Adaptaflex Non-Metallic Systems Accessories - Nylon Locknuts - LNP

Nylon Locknut - LNP - Product range update notification - Metric fitment

M50 thread shown

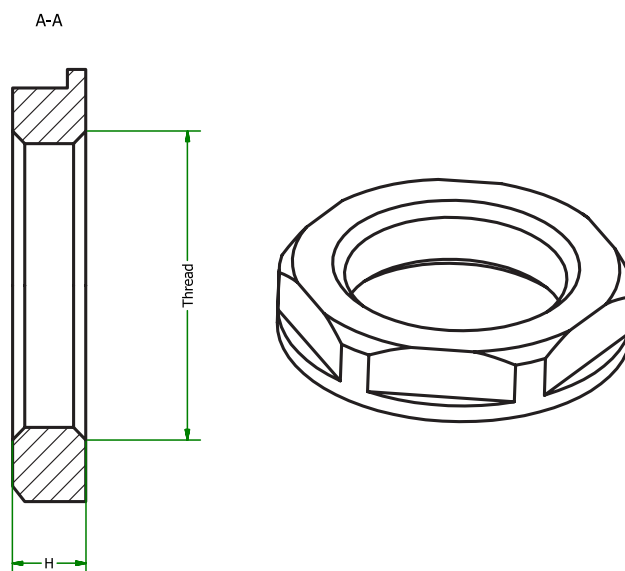
The Nylon Locknuts - LNP have changed to a newer smooth design. Although there is a difference in the Outer Diameter, this difference **does not** exceed the overall diameter of the mating parts.

With the change in design there is also the added advantage of the increased strength, due in part to increased wall thickness, but also to a change in material to glass filled nylon.

Below are a couple of visual examples of the new and old locknuts for reference. The new redesigned version is on the **LEFT** and the old version on the **RIGHT**.
